Addendum No. 2

Project: CM 5 Bathroom Remodel

KMB Job No.: 25012

FLOOR PLAN

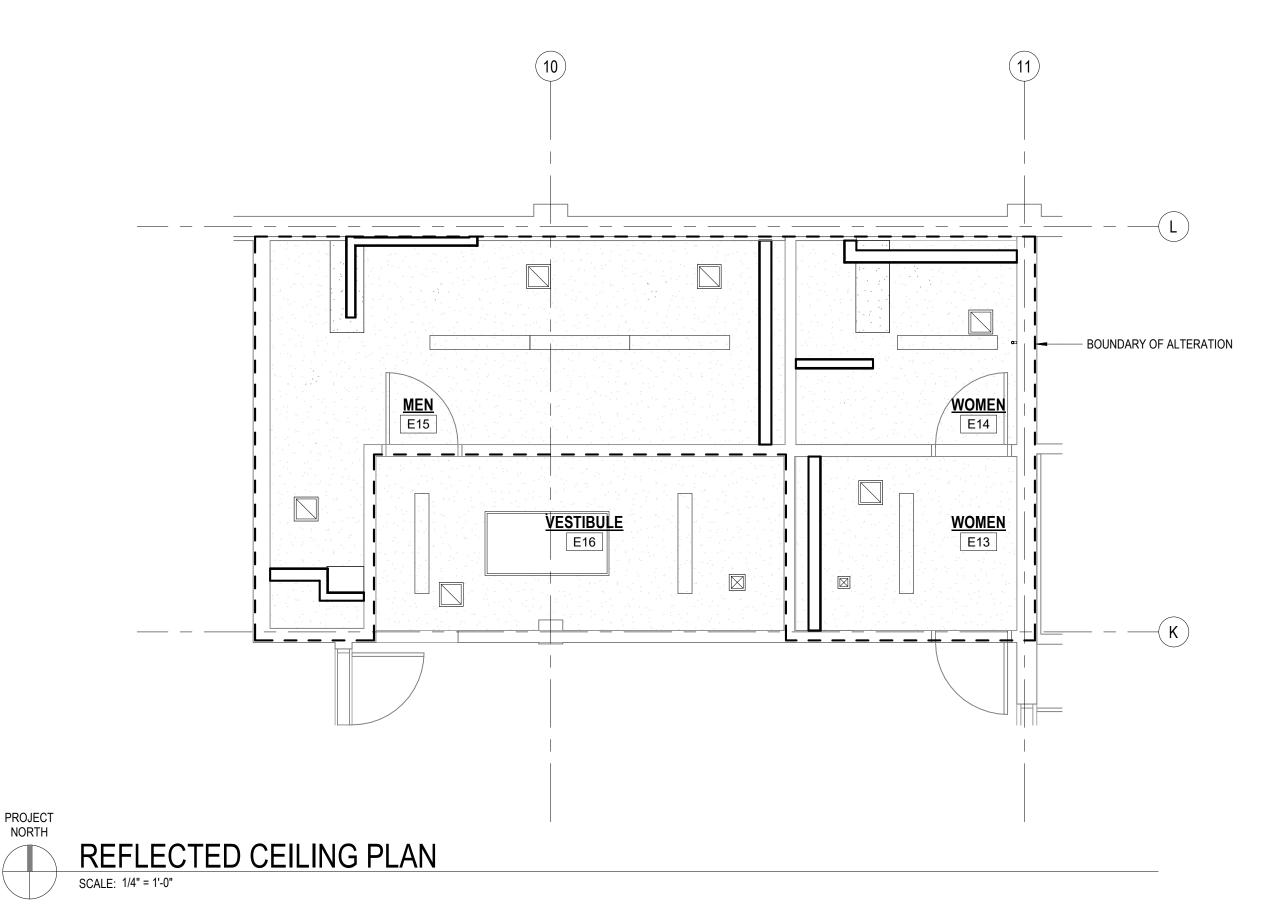
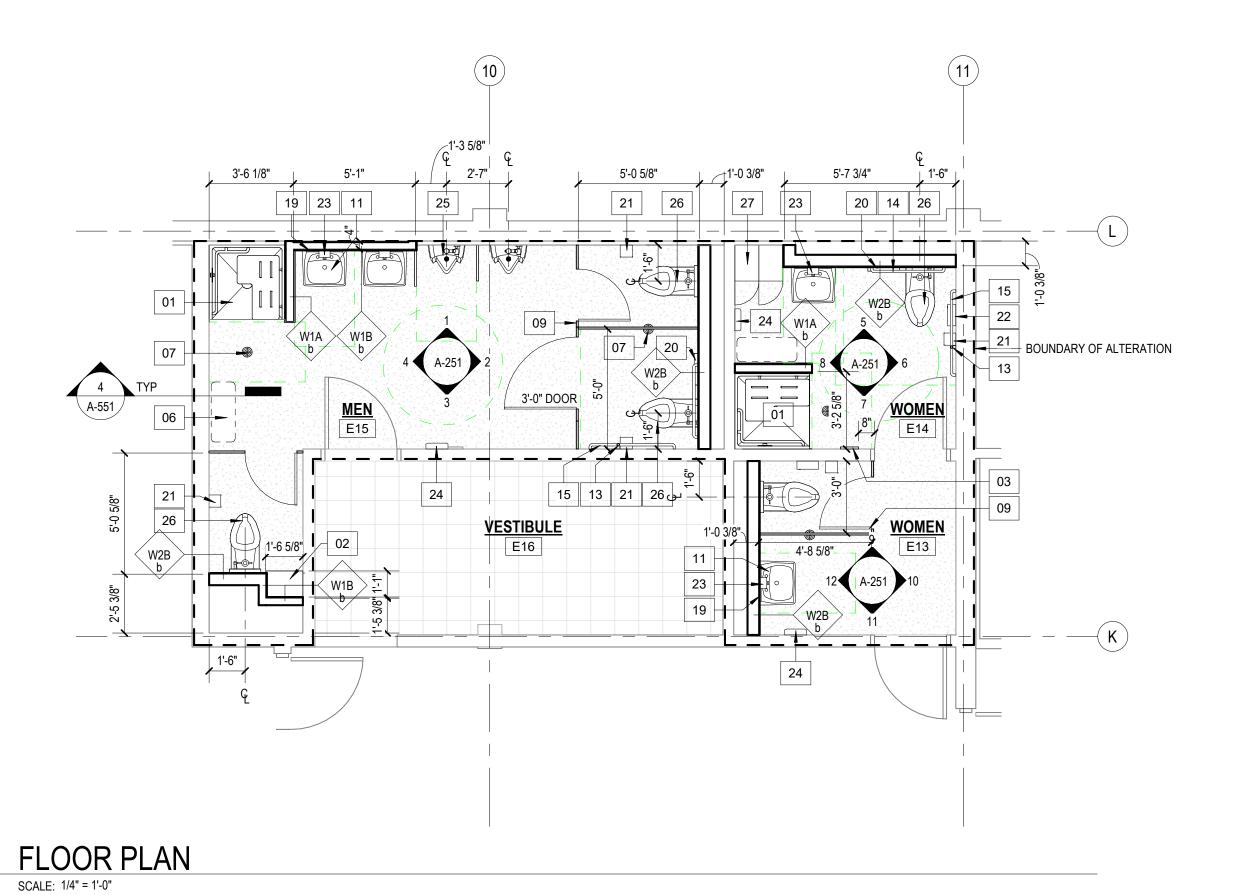
- 4. QUESTION: PLEASE CONFIRM IF FLOOR DRAIN LOCATIONS ARE PRECISE, REGARDING KEYNOTE #07 ON A-101
 - **A.** Response: A-101 KEYNOTES, NO. 07. <u>REVISE</u> TO READ: SET FLOOR DRAIN AT 3/4" BELOW FINISH FLOOR TAPER / SLOPE SURROUNDING CONC FLOOR SLAB TO DRAIN.

- 5. QUESTION: THE SPECIFICATIONS UNDER GYPSUM BOARD ASSEMBLIES SECTION 2.02 A, STATES TO USE MOISTURE-RESISTANT BOARD FOR ALL WALLS. HOWEVER, THE FLOOR PLAN DRAWINGS WALL TYPE NOTES 2 INDICATE THE USE OF CEMENTITIOUS BACKER BOARD FOR GWB WALLS

- 6. SHEET A-101
 - A. FLOOR PLAN
 - revise KEYNOTES, NO. 07 to read: SET FLOOR DRAIN AT 3/4" BELOW FINISH FLOOR - TAPER / SLOPE SURROUNDING CONC FLOOR SLAB TO DRAIN.
 - 2) <u>revise</u> WALL TYPE NOTES, NO. 2 to read: SUBSTITUTE MOISTURE-RESISTANT BOARD FOR GWB AT ALL TOILET ROOMS, LOCKER ROOMS, SHOWER AREA AND WET WALLS.

- **A.** Response: A-101 WALL TYPE NOTES, NO. 2. <u>REVISE</u> TO READ: SUBSTITUTE MOISTURE-RESISTANT BOARD FOR GWB AT ALL TOILET ROOMS, LOCKER ROOMS, SHOWER AREA AND WET WALLS.

- 1. ALL GWB TO BE TYPE "X" UNO. 2. SUBSTITUTE MOISTURE-RESISTANT BOARD FOR GWB AT ALL TOILET ROOMS, LOCKER ROOMS, SHOWER AREA AND WET WALLS. REFER TO FINISH SCHEDULE FOR WALL FINISH

- ADA COMPLIANT SHOWER INSERT WITH FOLD-DOWN STOOL
- AND GRAB BARS BUILT-IN SHELVING
- __RE-INSTALLED WALL HEATER, SEE ELEC
- OFOLPORTABLE SHOWER BENCH SET FLOOR DRAIN AT 3/4" BELOW FINISH FLOOR - TAPER / SLOPE SURROUNDING CONC FLOOR SLAB TO DRAIN
- /OVERHEAD BRACED, METAL TOILET PARTITIONS (TCP) LAVATORY FAUCET - SEE MECH
- GRAB BAR, VERTICAL 18"
- GRAB BAR, BACK WALL 36"
- GRAB BAR, SIDE WALL 42" MIRROR - 24"X36"
- SEAT-COVER DISPENSER SURFACE MOUNTED
- TOILET TISSUE DISPENSER
- SANITARY NAPKIN DISPOSAL
- HAND-SOAP DISPENSER
- PAPER TOWEL DISPENSER
- WALL HUNG URINAL SEE MECH WALL HUNG TOILET - SEE MECH
- 12" SINGLE-TIER METAL LOCKER
